Applicant: Lectrosonics, Inc.  
581 Laser Road  
Rio Rancho, NM 87124

Re: Response to Correspondence reference number 31725

Equipment: FCC ID: DBZUM450H, 731-confirmation number EA248053

Photograph showing separation distance from the back of equipment to the antenna.

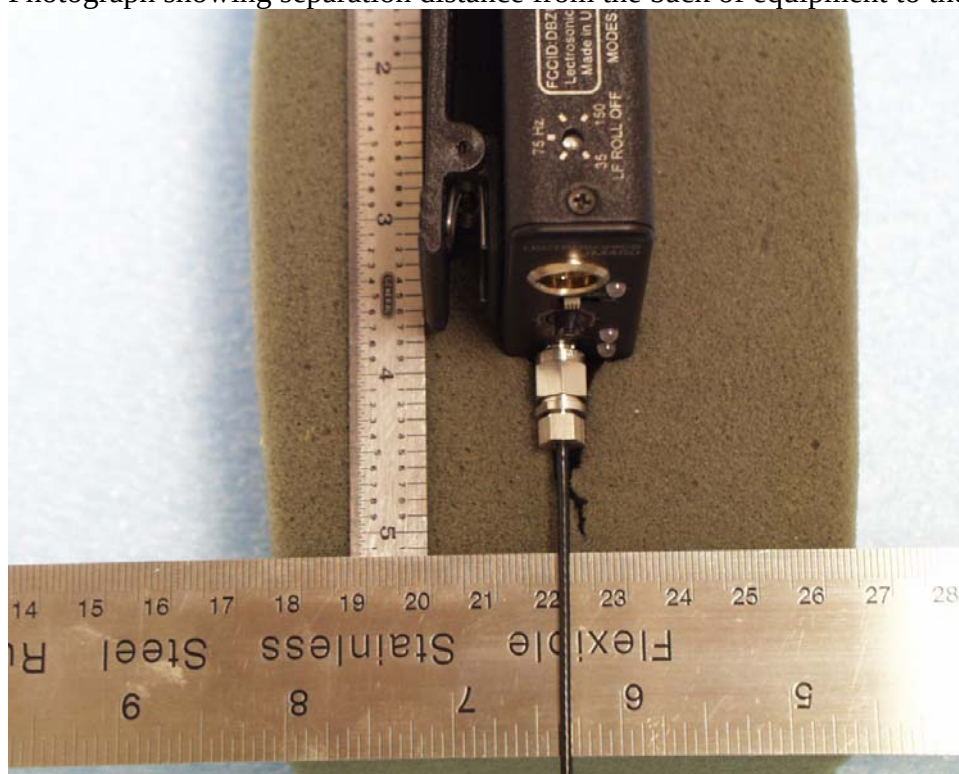
To support FCC RF exposure compliance determination, please submit photos and/or sketches for product with antenna installed showing spacings between the plane of the back of the belt-clip to: a) the back of the device, b) the closest point(s) of installed-antenna(s) FCC will then review all filing info to determine whether other info may need to be requested to support compliance with RF exposure requirements as applicable for all transmitters regulated by FCC. It may help to expedite this review if applicant has available and wishes to voluntarily submit SAR test results for this specific product

Below please find relevant photographs per your request demonstrating spacing between the back of the device and antenna, and the back of the clip and antenna.
